TRANSMITTAL LETTER FOR THE RESPONSE TO U S NAVY COMMENTS ON OPERABLE  
UNIT 1 (OU 1) CAP DESIGN NWS EARLE NJ  
11/7/1997  
BROWN AND ROOT ENVIRONMENTAL

Subject: Response to Comments  
Design Development Submission (DDS)  
Operable Unit 1 (OU-1) Cap Design  
Naval Weapons Station Earle (NWS Earle)  
Colts Neck, NJ

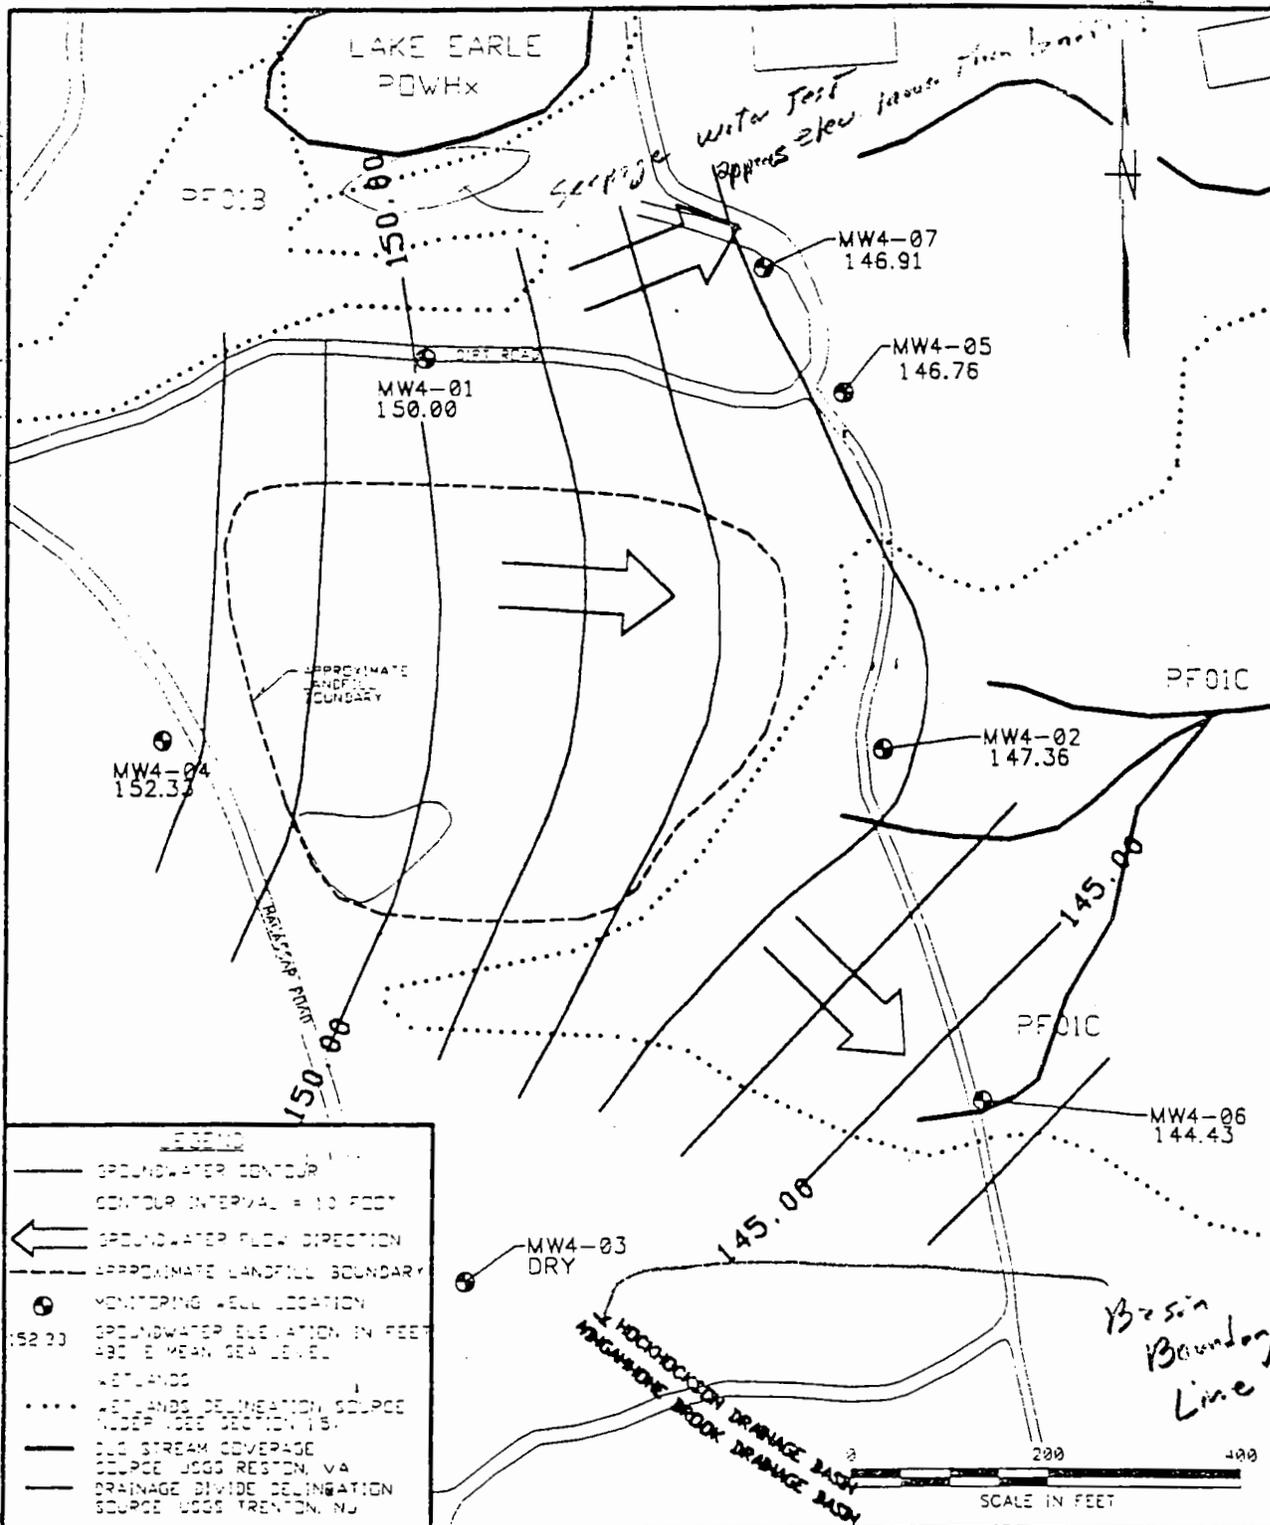
**Page 3-5, Figure 3-2: groundwater flow direction and surface water divides.**

*Does this intend to mean line is still in service. probably not*

B&R Environmental will change wording as follows: It is likely that this line is no longer in service.

Figure 3-2 provides general groundwater flow direction under Site 4. Groundwater contours near Lake Earle most likely wrap around this water body but sufficient water elevation data were not available to allow more detail.

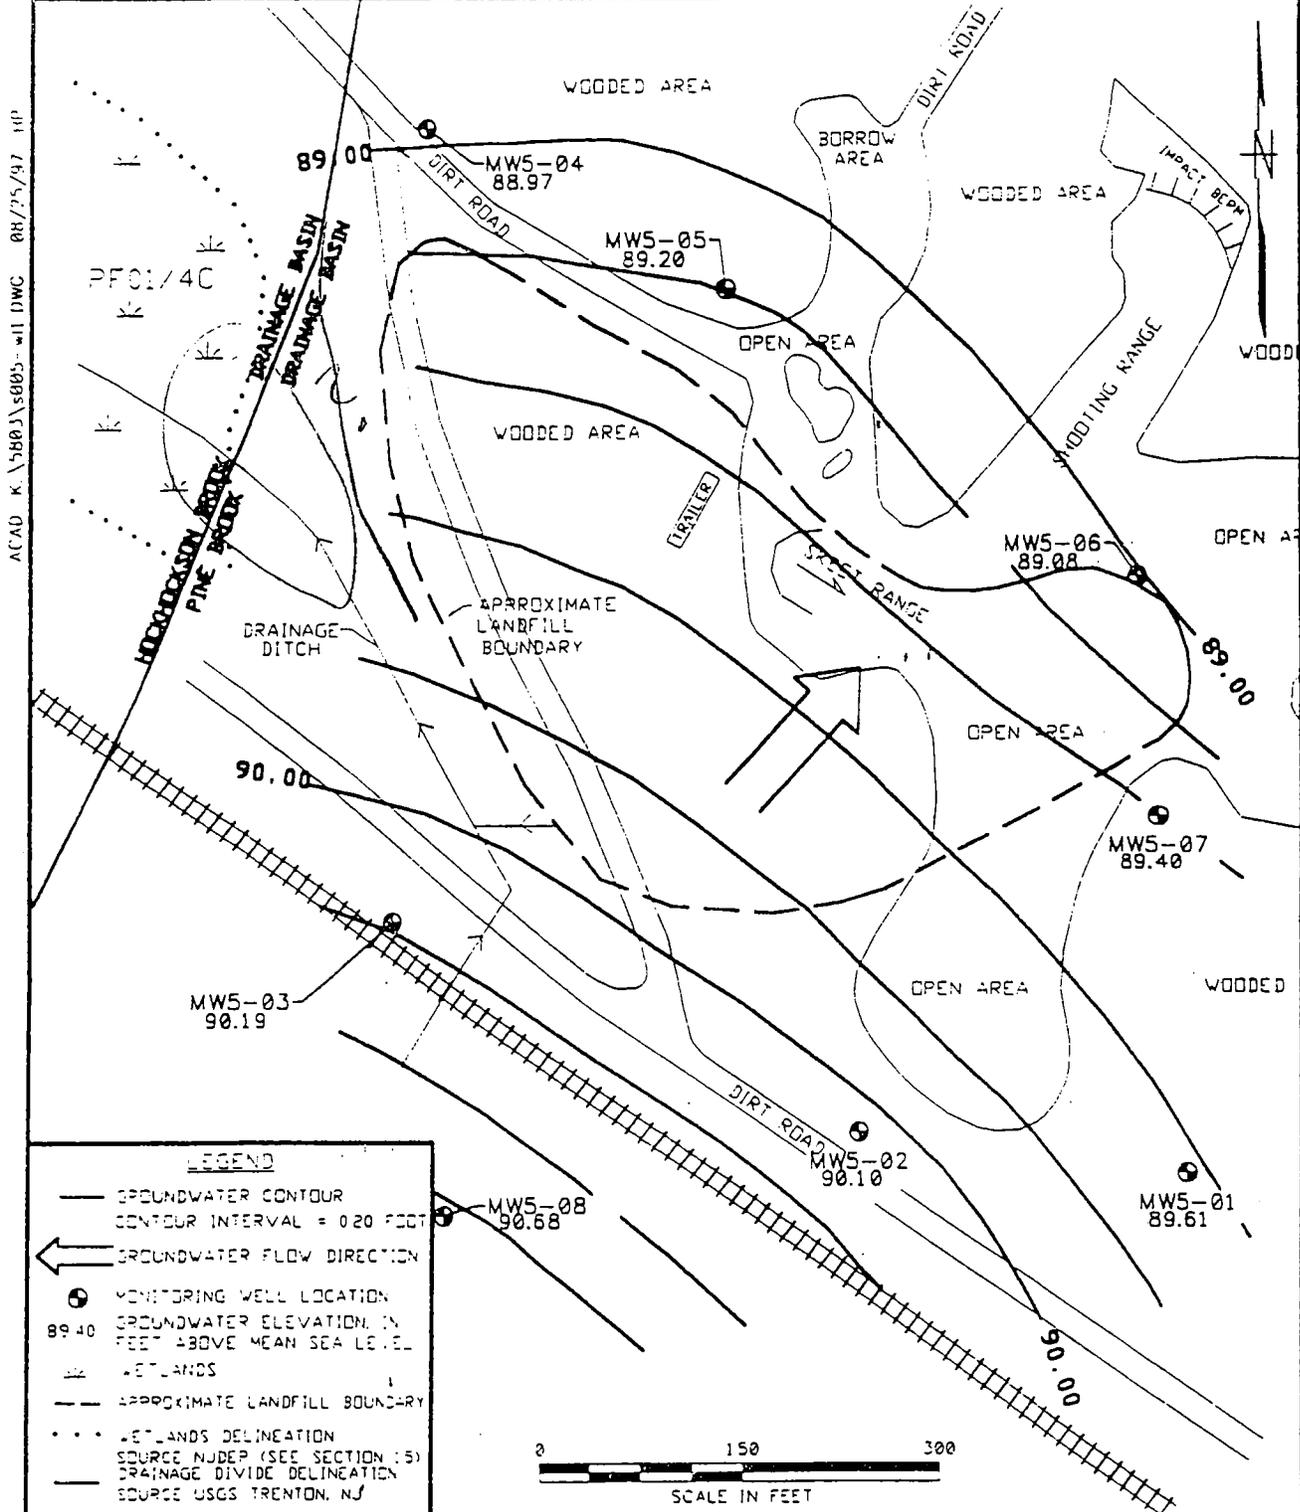
**Figure 4-2 and 4-3, Pages 4-6 and 4-7: Surface water divides and drainage.**

As discussed in comment no. 7, drainage water divides on these figures are not very accurate at the site level. Refer to the design drawings and the E&S Plan for more accurate site information.

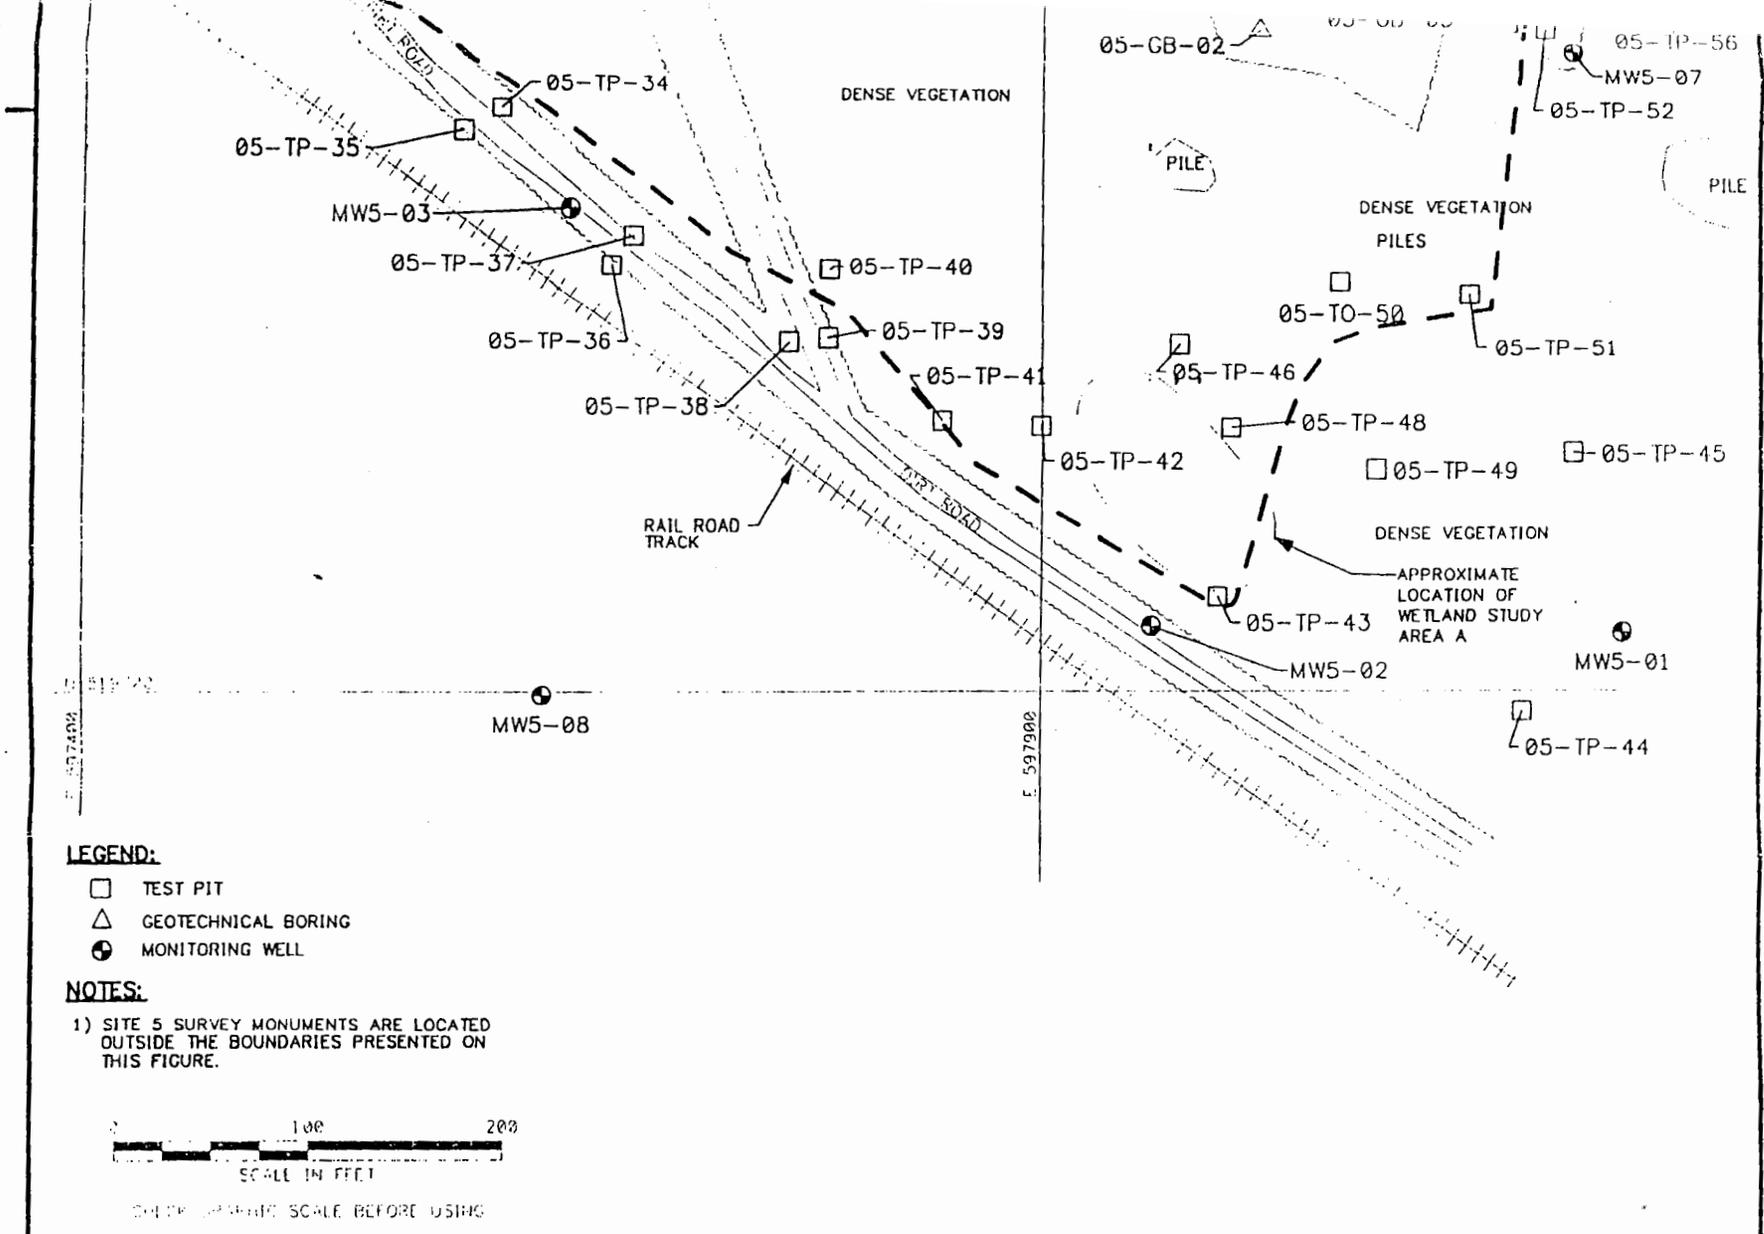
**Figure 5-2, Page 5-9: Location of wetlands.**

Wetland Area C is not depicted on Figure 5-2 (located west of Wetland Area B - off the drawing)
